PLANNING TECHNICAL REVIEW COMMITTEE –AGENDA

1. 10:30 AM – 11.00 AM: Site Review for R&P Singh LLC, (Owner: Aranosian Oil Co., Inc.), Assessor's Map 15, Lot 71, zoned B-5, located at 52 Central Avenue. (Proposal is to add a drive-thru service window). *[Previously heard on February 23, 2017]*. (P17-14)

Subject: Drive-Thru Window Service
52 Central Avenue
Tax Map 15, Lot 71
Dover, New Hampshire
Job No. 15112

Subject: Traffic Impact and Access Study Peer Review

SP-1

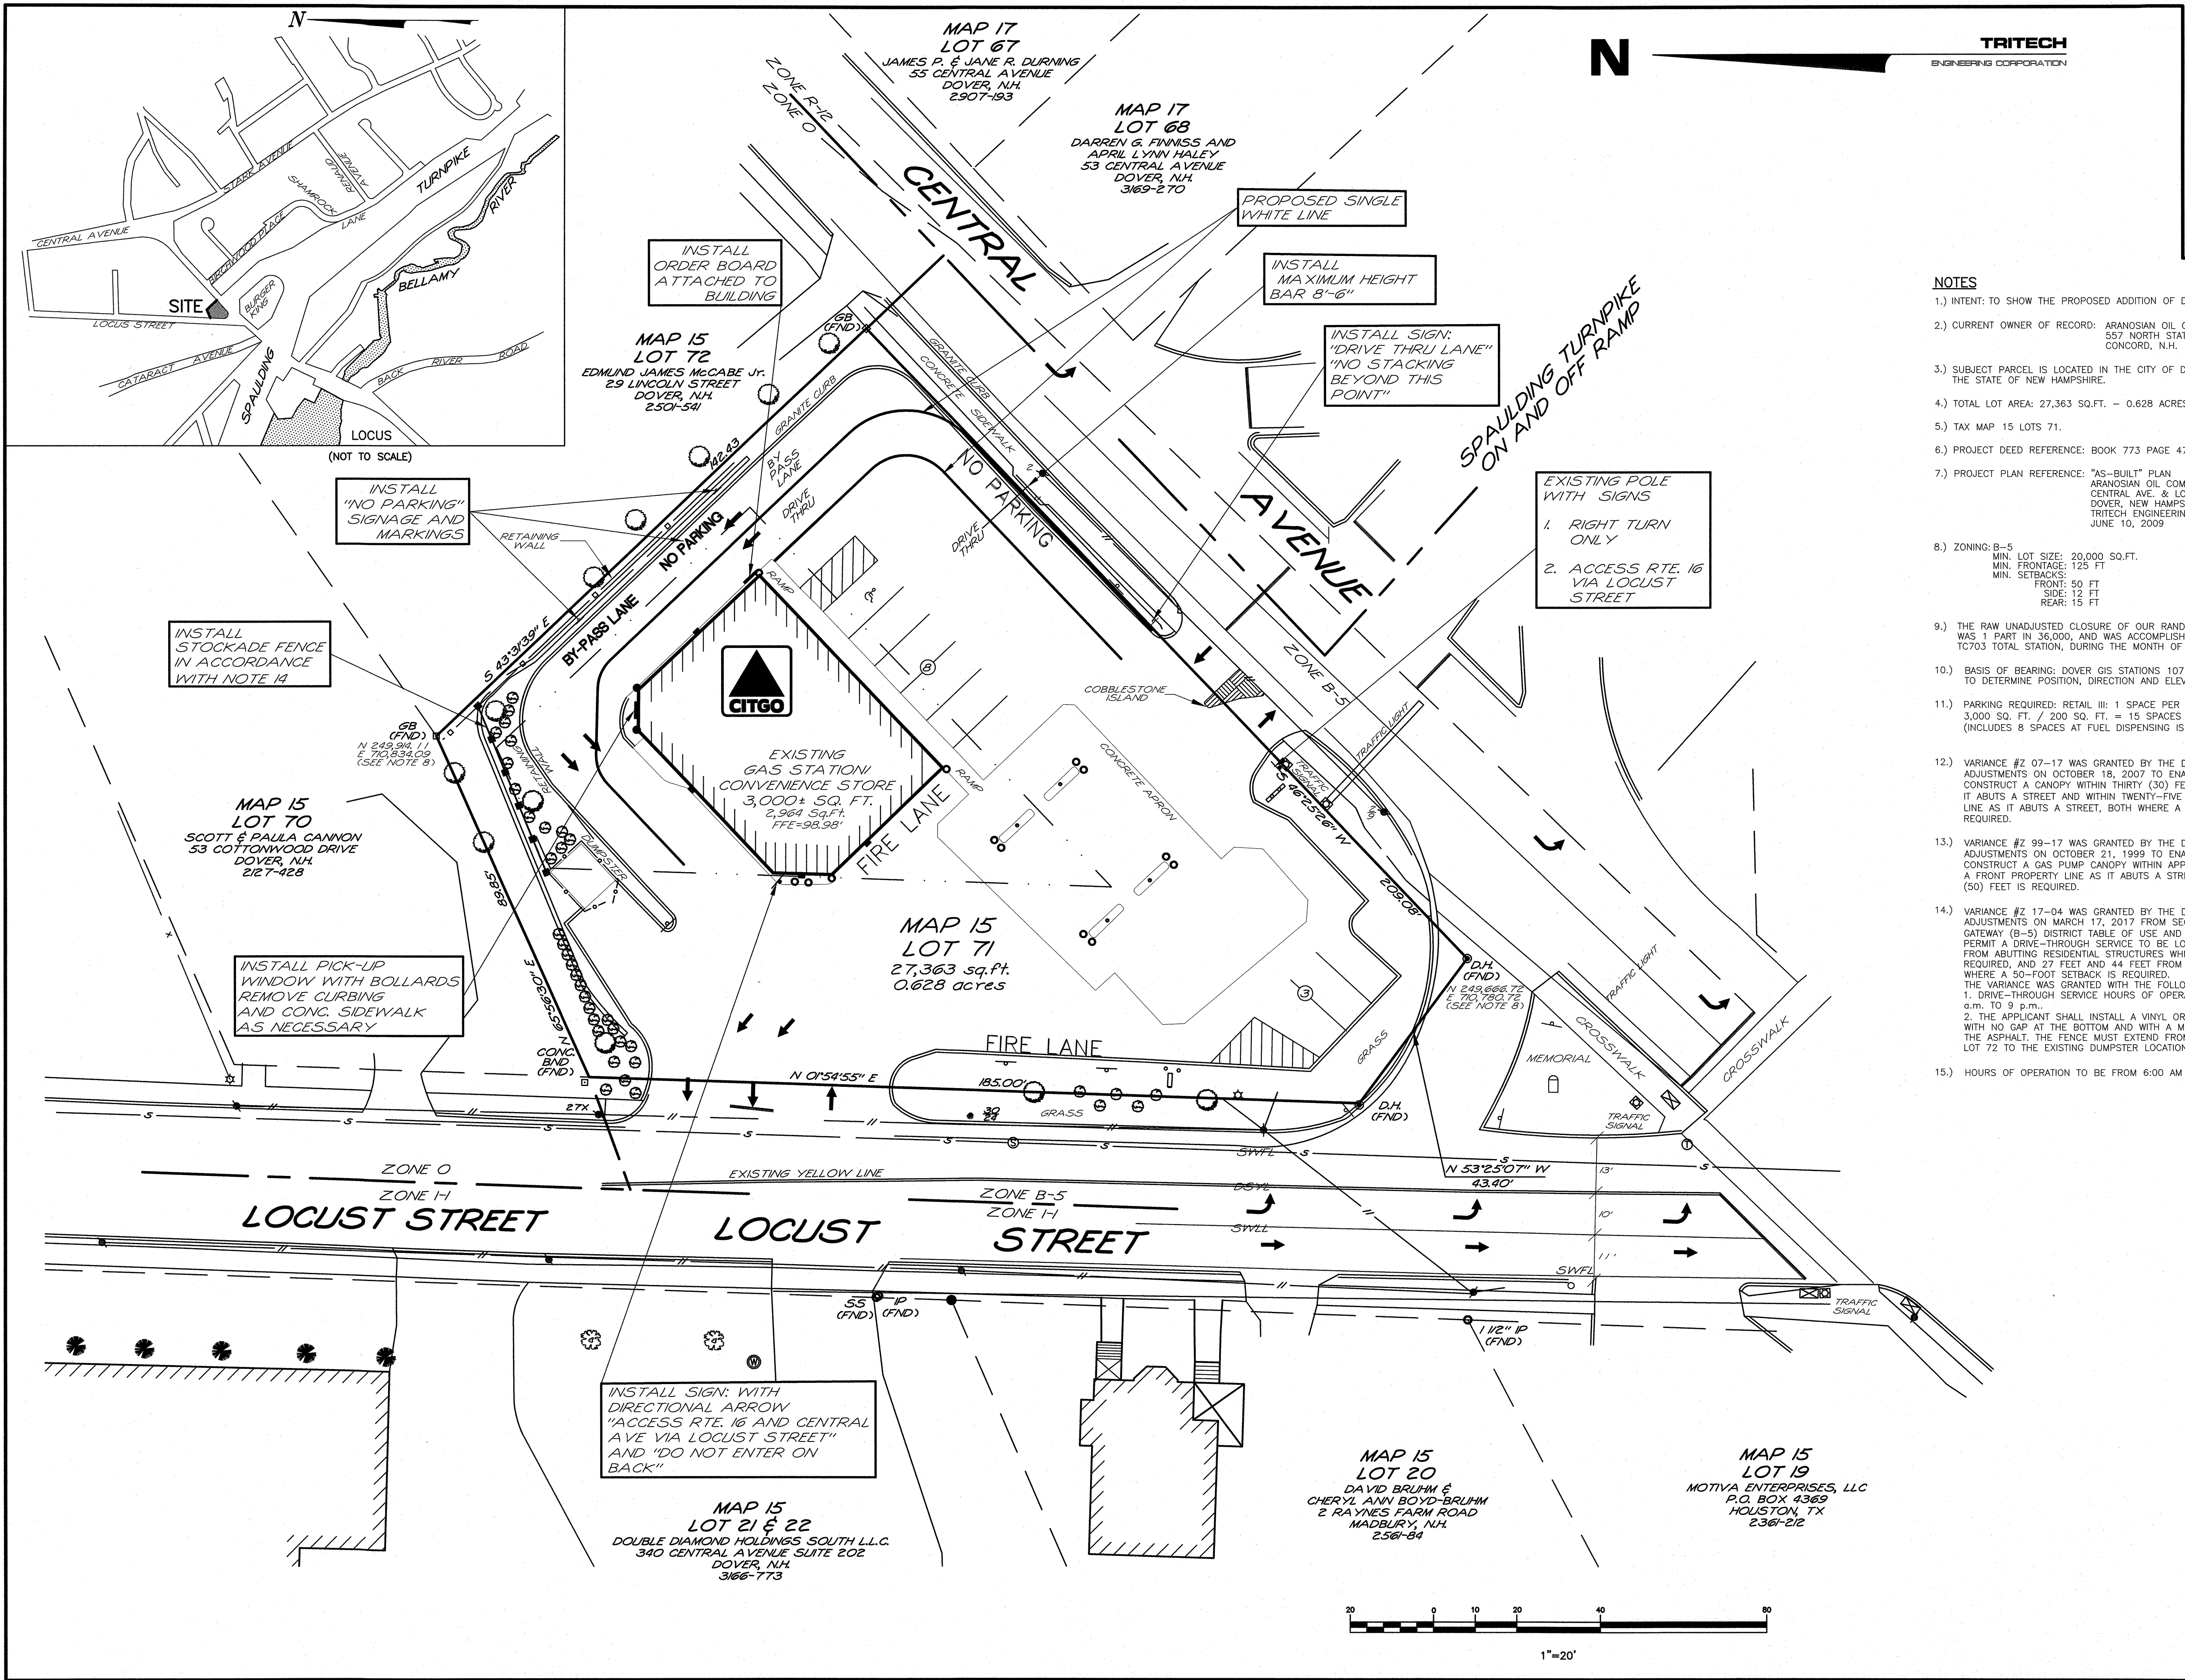
- Variance needed for the drive-thru near residential use
- Water and sewer investment fees will be assessed if necessary
- Who uses the bypass lane and how do you see it used?
- Provide:
 - Neighborhood plan with aerial and abutter information
 - Streetscape (including call box)
 - Traffic Impact Analysis
 - Architectural Renderings to plan set and revised to meet 149.14.L
- Please revise the plan set to:
 - Add signature and stamp of the LLS and PE
 - Add Planning file number P17-14 to plan set
 - Add a note indicating the hours of operation (earliest time is 6:00am and latest time is 9:00pm)
 - Add abutting property information
 - Label Central Ave
 - Add landscaping information
 - Add signage directing traffic from Locust to the drive-thru
 - Revise note 12 to add the variance information for Z99-17

- If there is a Traffic Impact Assessment, would like to review it
- Concerned about capacity for Locust Street signal queue
- Post by-pass lane as No Parking
- Add directional arrow to the proposed "Access Route 16" sign, and also a Do Not Enter sign on the back of it
- What is the height/construction of easterly fence across from the drive-thru order board? Concerned about sound projection.
- Concerned about potential safety conflict at pick-up window with adjacent exterior door. Door opens blind into the path of car exiting the drive-thru.
- Establish and post a maximum height bar at drive-thru queue point
- Add sign at driver-thru queue point, "No Stacking Beyond This Point"

- It does not look possible for a vehicle to drive up to the window and avoid the sidewalk for the back exit. How will this be solved? (Photo attached)
- Consider looking at vehicle height restrictions.

- Is a truck able to turn with the island?

- Would like information on speaker system and volume of system
- Place plantings next to fence
- What is the lighting like in the back?

- Variance needed for the drive-thru near residential use.
On March 16, 2017, the applicant was granted a Variance from the Dover Zoning Board of Adjustment. The Zoning Board placed two (2) conditions on their approval. These conditions have been incorporated into the revised plans.

- Add Planning file number P17-14 to Plan Set
The file number "P17-14" has been added to all sheets.
 - Add a note indicating the hours of operation (earliest time is 6:00am and latest time is 9:00pm)
This note has been added to the revised plan.

- Add abutting property information
This information has been added to the revised plan.
 - Label Central Ave
Central Avenue has been labeled on the revised plan.

- Add landscaping information
The existing landscaping has been added to the revised plan. Additional fencing is proposed as shown, however no additional landscaping is proposed.

- Add signage directing traffic from Locust to the drive-thru
This is addressed in the Traffic Response. This signage is unnecessary.
 - Revise note 12 to add the variance information for Z99-17
This note has been added to the revised plan.

- Concerned about capacity for Locust Street signal queue
This project will have no impact on the Locust Street signal.
- Post by-pass lane as No Parking
No parking signage has been added to the revised plan.

- Add directional arrow to the proposed "Access Route 16" sign, and also a Do Not Enter sign on the back of it
This revision has been added to the revised plan.

- Establish and post a maximum height bar at drive-thru queue point
This has been added to the revised plan.
- Add sign at driver-thru queue point, "No Stacking Beyond This Point"
This has been added to the revised plan.

- It does not look possible for a vehicle to drive up to the window and avoid the sidewalk for the back exit. How will this be solved? (Photo attached)
A portion of the existing curbing and concrete landing will be removed to ensure adequate access to the drive-up window.
- Consider looking at vehicle height restrictions.
A height restriction has been added to the revised plan.
